RE: Submission of 2022 Geotechnical Inspection Report No. 2 (September 2022)

2022 Geotechnical Inspection Report No. 2

Baffinland Iron Mines Corporation

Figure 20: Drainage ditch next to the crusher plant leading to the MS-06 pond. The yellow circle indicates that the entry to the culvert that should drain the collected surface water from the ditch to the MS-06 pond is partly clogged (should be cleaned). Extending the culvert is also suggested.

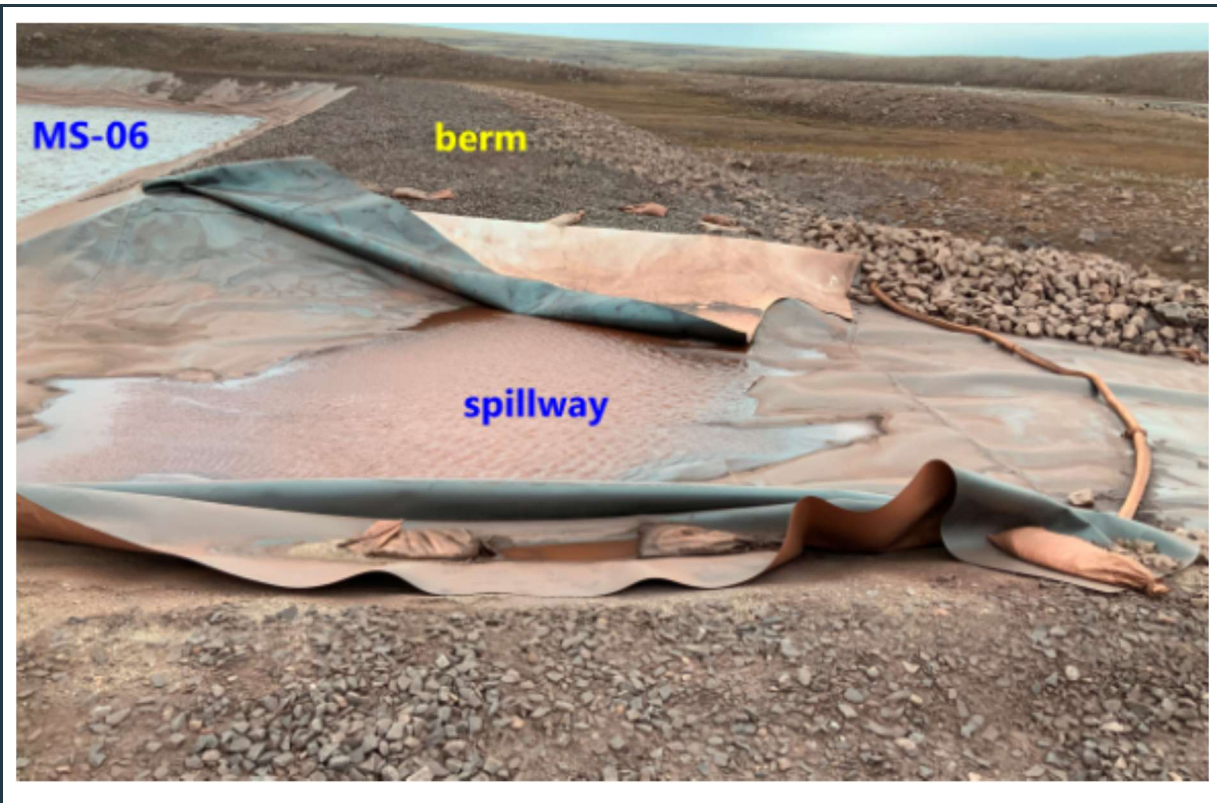
The MS-06 surface water management pond collects surface water from the area of the crusher pad. The surface water is collected in side-ditches, excavated around the crusher pad, and conveyed into the pond. There is one culvert under the crusher pad entrance that connects one (1) of the side ditches with the north corner of the surface water management pond. It was noted during the September 2022 inspection that the inlet-end of that culvert is still partly clogged with soil (see Figure 20). The location of the clogged end of the culvert is marked by a green dot in Figure 1 (within the yellow circle marking the MS-06 pond). The soil fill, blocking the flow of water through the culvert, must be completely removed to restore proper drainage through this culvert. Extension of the culvert is also suggested to prevent future clogging of this corrugated drainage pipe.

c) MS-08 pond and drainage ditches next to the waste rock facility

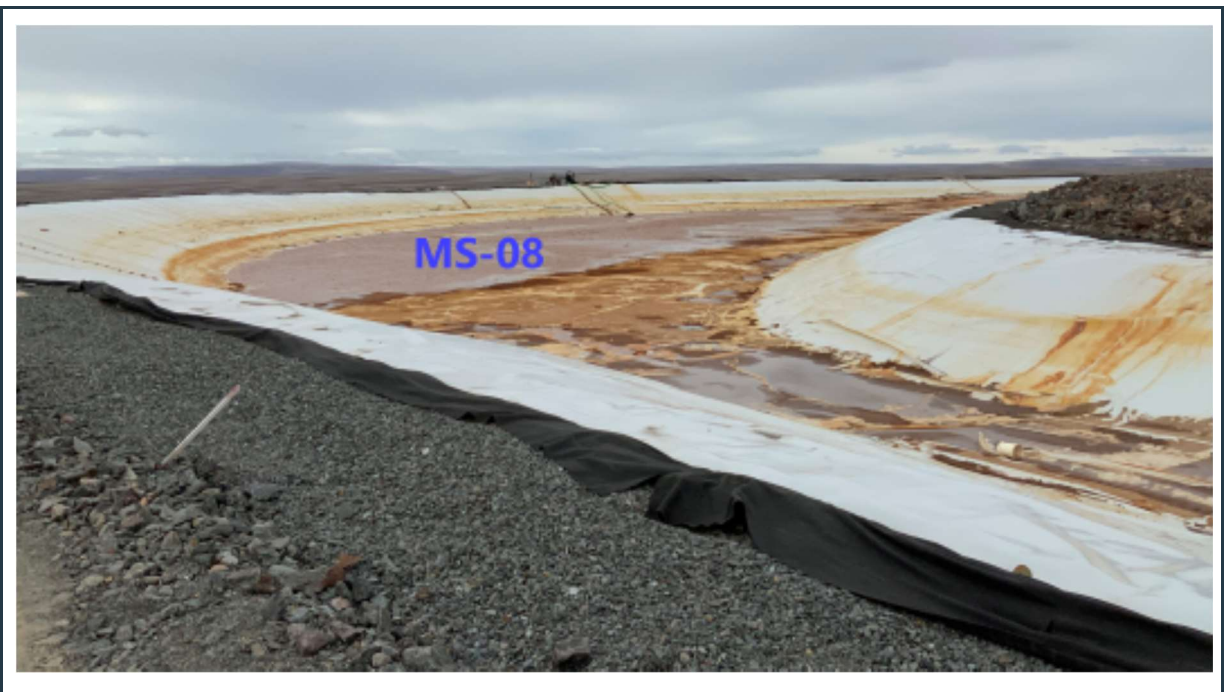
As pointed out earlier, contact water from the WRF is collected in perimeter ditches and the collected water flows to the surface water management pond from the east and west. As shown in Figure 25 and Figure 26, the drainage ditches are generally well maintained, and have stable side-slopes. However, one section at the west ditch is blocked by waste rock, as shown in Figure 25. It is suggested to excavate a new section of the ditch along the yellow line shown in the image, to facilitate easier flow of surface water to the pond. Simple removal of waste rock from the existing ditch would result in more boulders rolling down from the adjacent steep waste rock slope into the ditch, hence, the excavation of a new ditch section would be preferred.

Figure 25: Drainage ditch around the west side of the waste rock facility. Note a short section of the ditch blocked by waste rock (purple arrows). It is suggested to excavate the ditch along the yellow line to facilitate easier flow of surface water within the ditch to the pond.

Figure 40: View of the currently empty Cell 2 at the land-farm. Note the exposed liner above the sump area. The slump of the soil cover is most likely related to the impact of the sump.

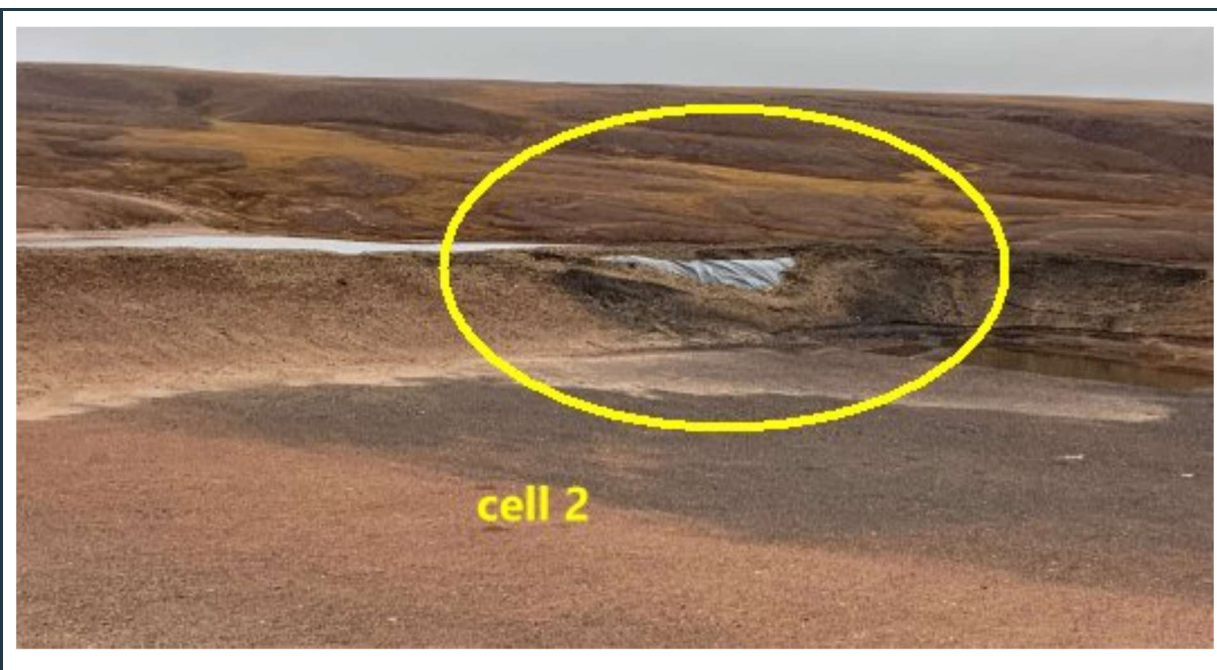
During the September 2022 inspection, the following deficiencies were noted at the two completed cells, shown in Figure 39 and Figure 40:

Figure 44: View of the rock face at the upper quarry level with some potential rolling rock hazard. Note the row of boulders placed on the crest and toe of the rock face to prevent unauthorized access to the wall. No activity is currently carried out in this quarry.

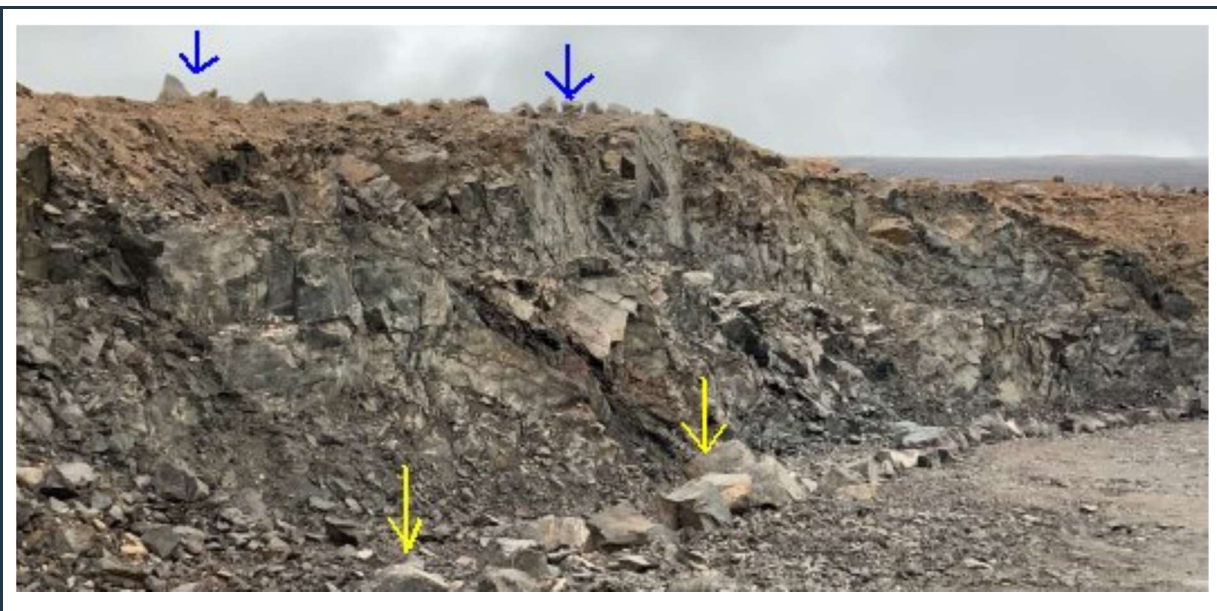
There is no blasting and excavation activity currently carried out in the QMR2 rock quarry (Figure 44). The exposed slopes (rock face) in the quarry appear to be in stable condition overall, with a few localized fall hazards (loose boulders) noted at the top level of the quarry walls in some areas. As shown in Figure 44, boulders are placed near the crest and along the toe of the exposed rock wall to prevent unauthorized access to the steep rock face.

Figure 47: View of the surface water diversion berm at the new KM-106 ore stockpile area. Note the water seepage through the berm into a temporary sump, downstream from the diversion berm. The water from the sump is periodically pumped into the new nearby MS-07 surface water management pond.

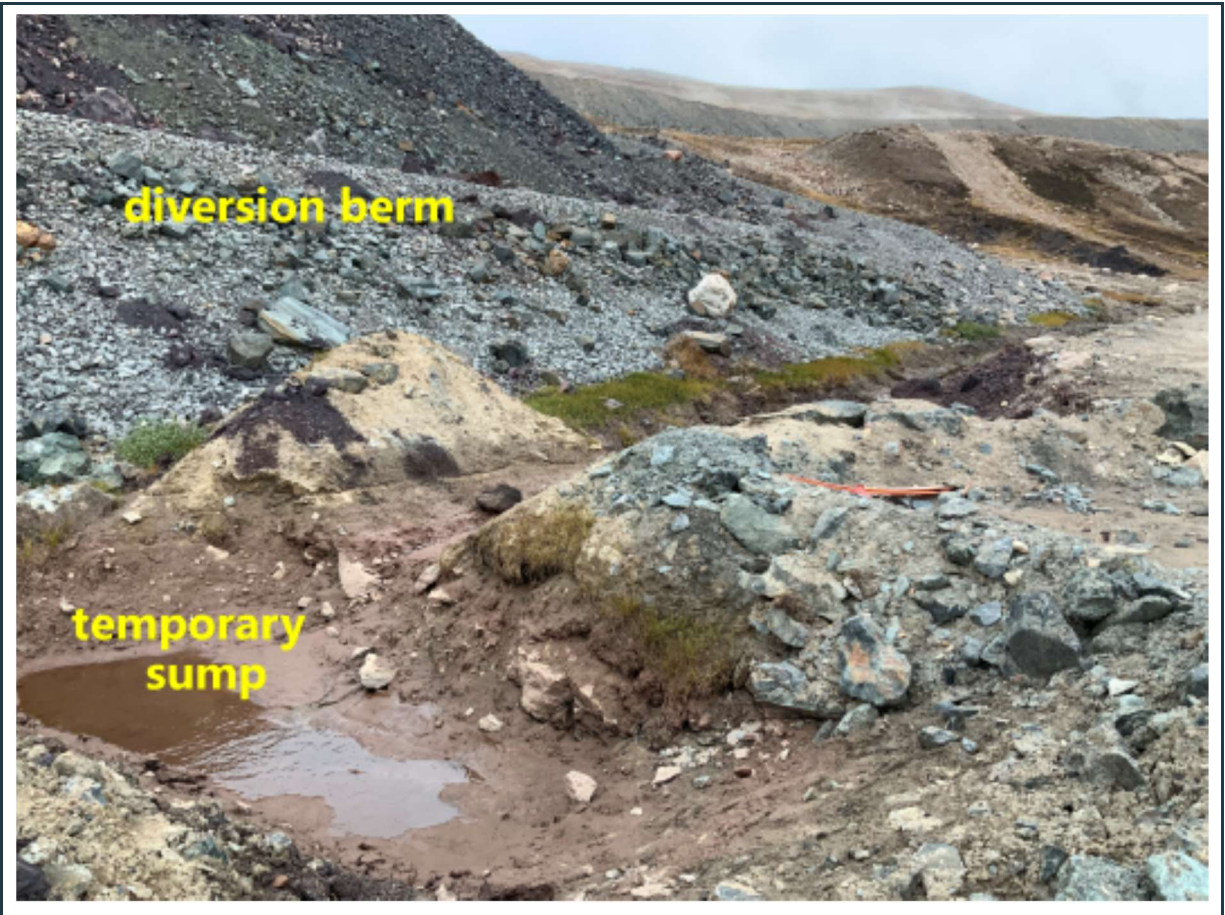
The area previously considered as the future D1Q2 rock quarry is now serving as a new ore (run-of-mine) stockpile site. As shown in Figure 3, the selected area is located south of the "deposit-1" open pit, along the east side of the mine haul road. It is also shown in Figure 3 that a surface water diversion berm was constructed along the east and south sides of the stockpile area. The "diversion" berm was constructed using granular fill that may not function well in diverting all surface runoff to the adjacent MS-07 pond. Some of the run-off water can seep through the berm at its bend, which is collected in a temporary sump (purple circle in Figure 3) downstream from the berm (Figure 47), and subsequently pumped into the nearby MS-07 pond. It is recommended to cover the base and slopes of the sump with riprap.

Figure 92: View of the face of the slope at KM 09+700. Note the slumping/spalling/raveling of material trickling/rolling down on sections of the face of the slope without endangering the traffic on the tote road, located well away from the slope.

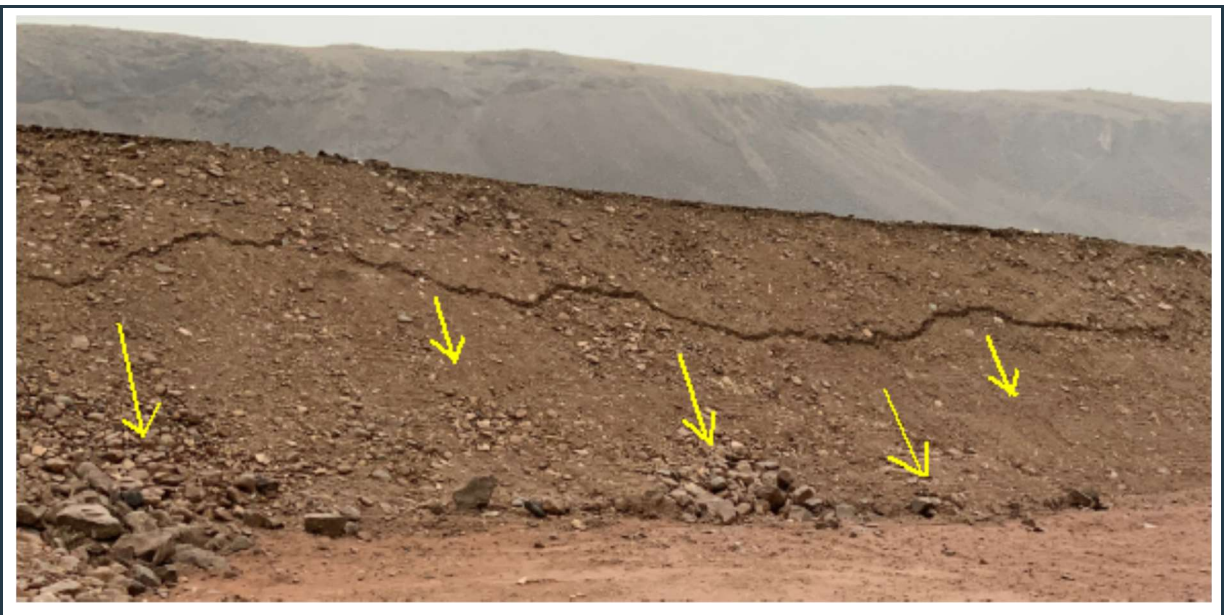
(spalling and raveling) on their faces, as it is visible in Figure 92. If the toe of these slopes is located away from the roads (at least the same distance as the height of the slopes) they do not present risk to the road structure or to the traffic on the road. For slopes immediately adjacent to the edge of the road; however, the ground conditions (local soil types, soil properties, seepage conditions) should be reviewed, and the slopes may need to be cut back to shallower inclinations (generally to 2H:1V, 2 units horizontal to 1 unit vertical, or about 27 degrees from horizontal).
